Service Bulletin

DATE: OCTOBER 1991

REF: JD 08/91

XJS

FIG 1

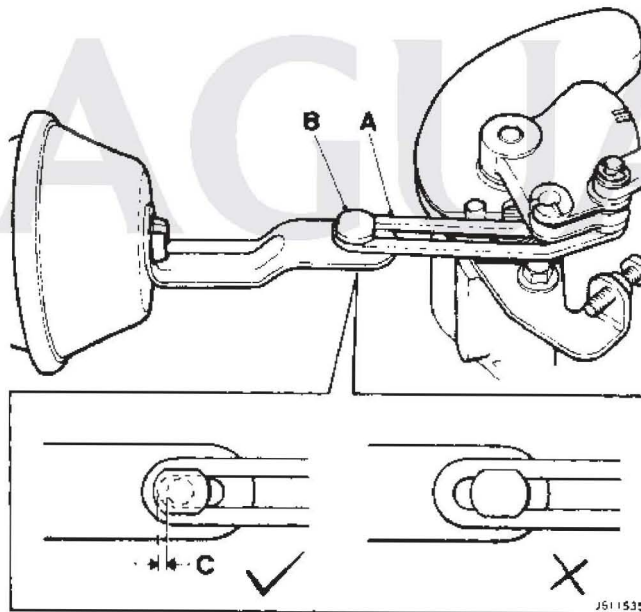
Dealers should ensure that the clearance between the end of the actuator to throttle link slot (A Fig 1) and the shoulder bolt (B Fig 1) is 0.5mm to 1mm (C Fig 1).

Fig. 1

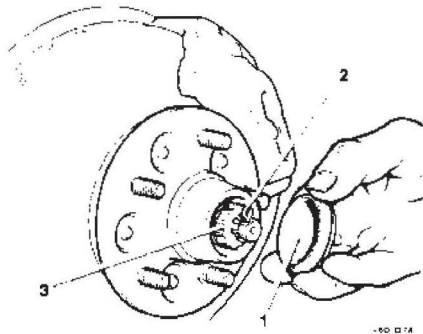
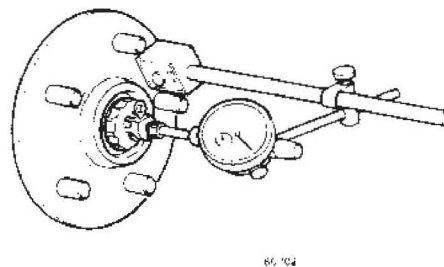
The following instructions supersede all previous instructions provided in service manuals. Manuals will be updated at the next reprint.

Front hub end float on the above models should be set between 0,0254 to 0,0762mm (0.001 to 0.003in). To achieve this in service use the following method:

Adjust the nut, as necessary, to give a reading of 0,0508mm + / - 0,0254mm (0.002in + / - 0.001in).

Always try to achieve the mid-point of the tolerance i.e., 0,0508mm (0.002in).

FIG 1

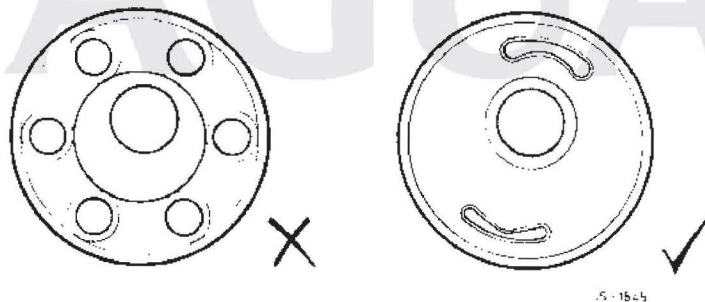
Note: The bushes originally used were termed as 'six-shooter' bushes. These have now been redesigned / replaced by the 'smiley-faced' bushes currently being used, see Fig. 1 for identification.

Fig. 1

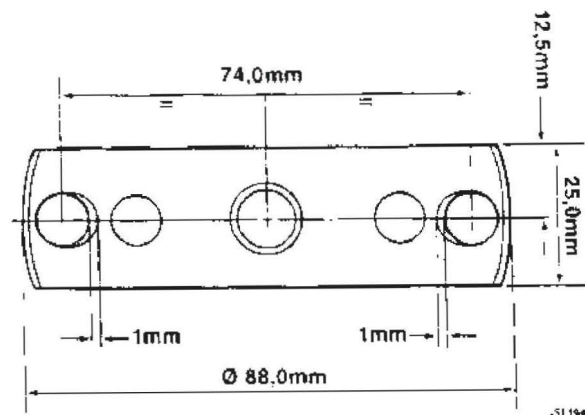
Following a running change to certain dimensions on the crankshaft damper, prior to the introduction of the V12 6.0L engine, it is necessary to carry out a minor corresponding modification to the Special Tool 18G 1436, to permit the use of the tool on this engine.

Modification is only required to the existing Special Tool, identified as 18G 1436, supplied to Dealers prior to January 1993. From this date all stock of the tool has been modified and identified by suffix 'A'. From January 1993, issues have only been made of the modified Special Tool, 18G 1436A.

Refer to Fig. 1. below. Using a round file, slot the outer two holes by 1mm each, towards the centre of the tool, as indicated by the highlighted zone in the illustration.

Fig. 1 Right hand spring.

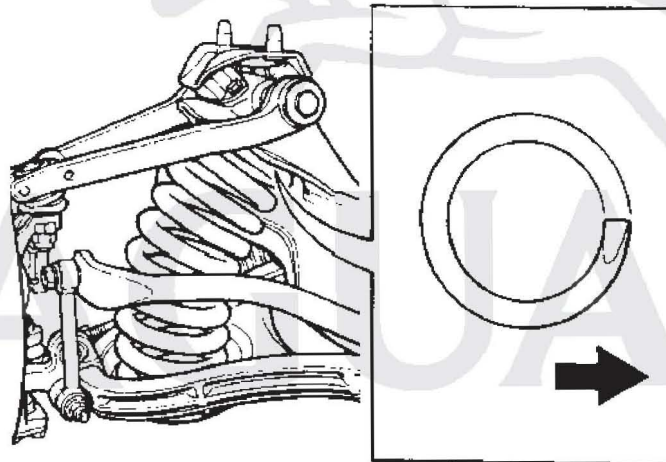
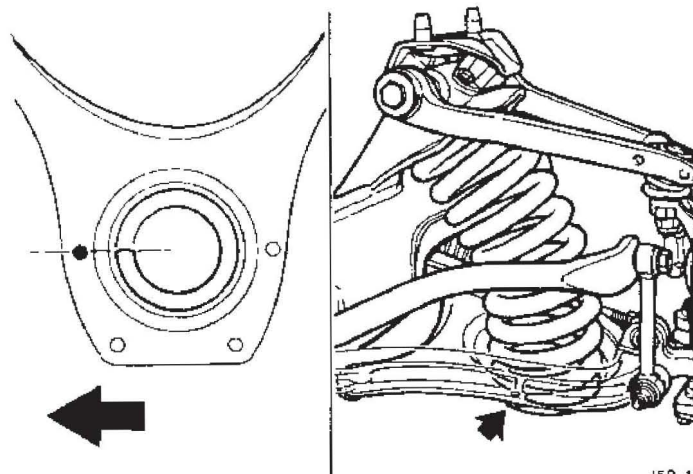
When fitting front road springs, to prevent a possible foul condition with the anti-roll bar, the springs should be fitted and aligned as follows:
